Review Comments on:  
*ALERT2 Application Layer Protocol Specification*  
Timothy J. Salo<sup>1,2</sup>  
January 18, 2011

This document contains the author's review comments for the *ALERT2 Application Layer Protocol Specification*, Version 1.0, dated September 1, 2010, published by the National Hydrologic Warning Council (NHWC). The primary intent of these comments is twofold: to improve the quality of the specification and to highlight specific technical issues that may warrant additional consideration.

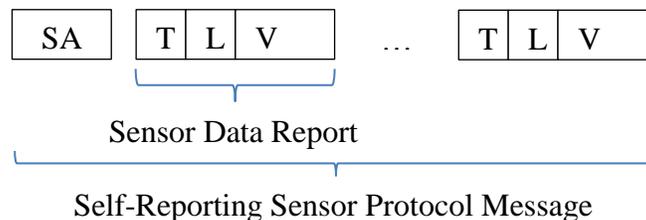
I strongly recommend that the specification explicitly describe a single ALERT2 application-layer protocol that is responsible for transporting sensor data from a wide variety of sensors. I suggest that this single application-layer protocol for sensor data be referred to as the “Self Reporting Sensor Protocol” or “SRS protocol”. This [single] application protocol should be identified by a single application layer protocol id (ALPID) in the ALERT2 link-layer protocol header (part of the AirLink protocol). Additionally, in this document I refer to the type-length-value structures that generally contain sensor data as “sensor data reports”, in order to avoid using the heavily overloaded term “message”.

I suggest that the diagram in section 2.1 of the specification be enhanced as shown below:
